SECTION 174 (ENFORCEMENT NOTICE) APPEAL REFERENCE: APP/L1765/C/18/3195411 Land known as Texas, Texas Drive, Olivers Battery, Winchester, SO22 4HT

Satellite Image dating from Spring 2017 showing the scale of the unauthorised works

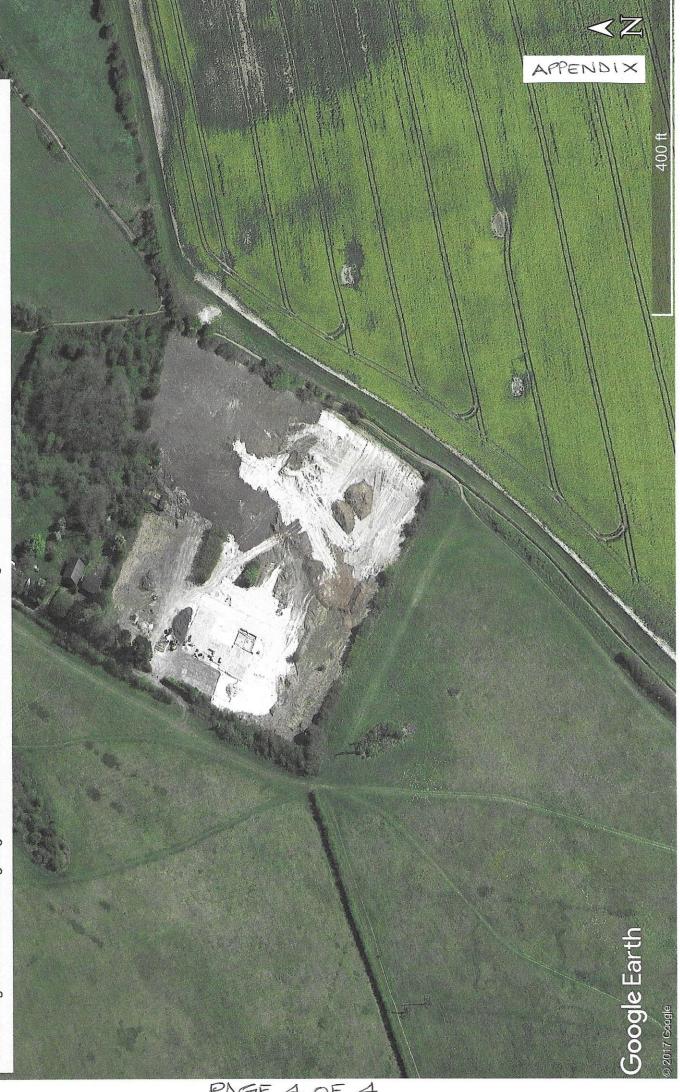
- The removal of the chalk downland surface vegetation over almost the entire site, not just in way of the new dwelling (see satellite image at Appendix).

Topsoil has already been redistributed over the north-eastern segment. The clump of trees in the centre of the site has since been removed. The footings for the attached garage are still visible on the front of the dwelling.
